**The Advertised Discretionary Planning Application PA \19\0242 from: PDA
Surveyors obo Roy Deane**

Location: 25 Wadleys Road Reedy Marsh 7304

**The Modified and Re-advertised Discretionary Planning Application PA \19\0242
from: PDA Surveyors obo Roy Deane**

Figure 2: Vegetation

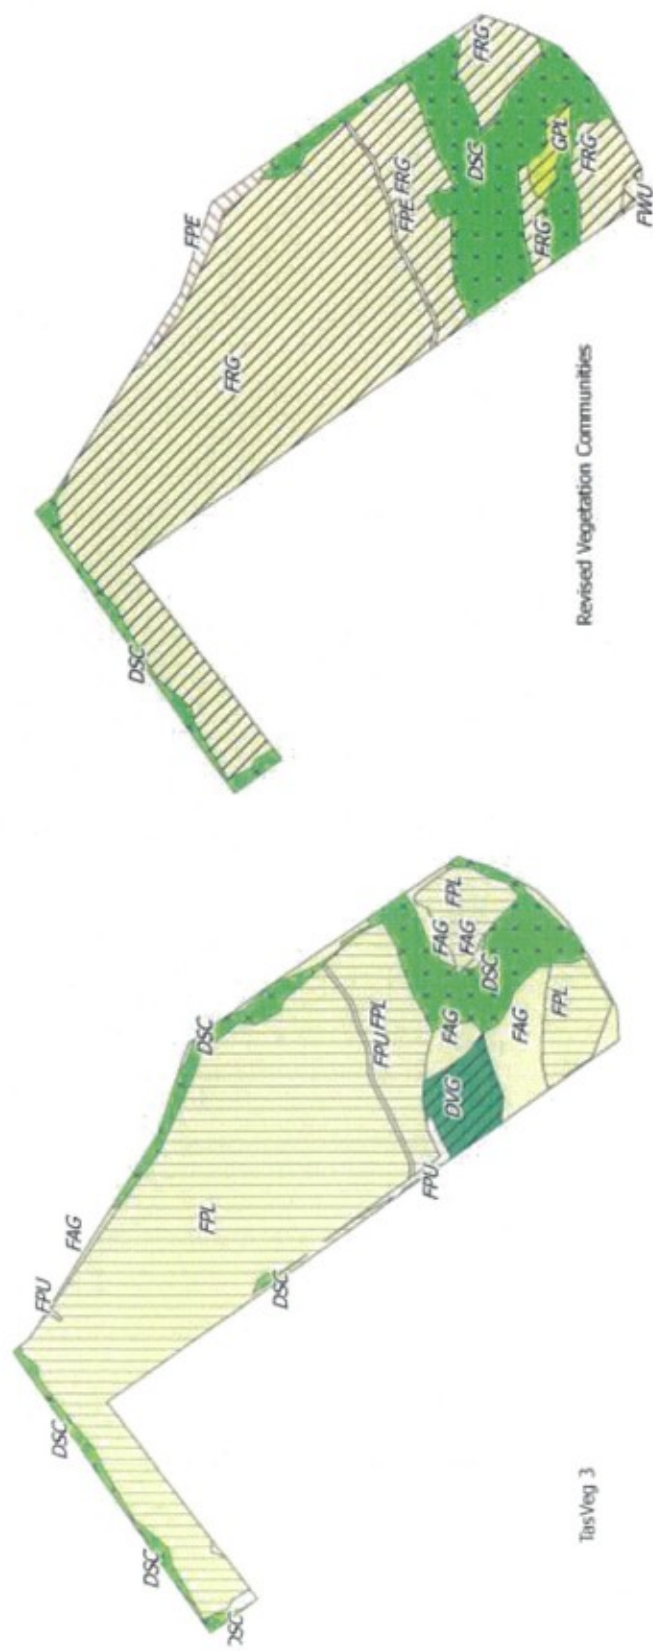
Mr Livingston of Livingston Natural Resource Services claims in his Natural Values Report, PDF page 63 ² that the TasVeg III map is not correct. He has also on the same page provided what he terms to be Revised Vegetation Communities. For clarity: He has not really revised the communities themselves but identified a different spatial extent of the various communities.
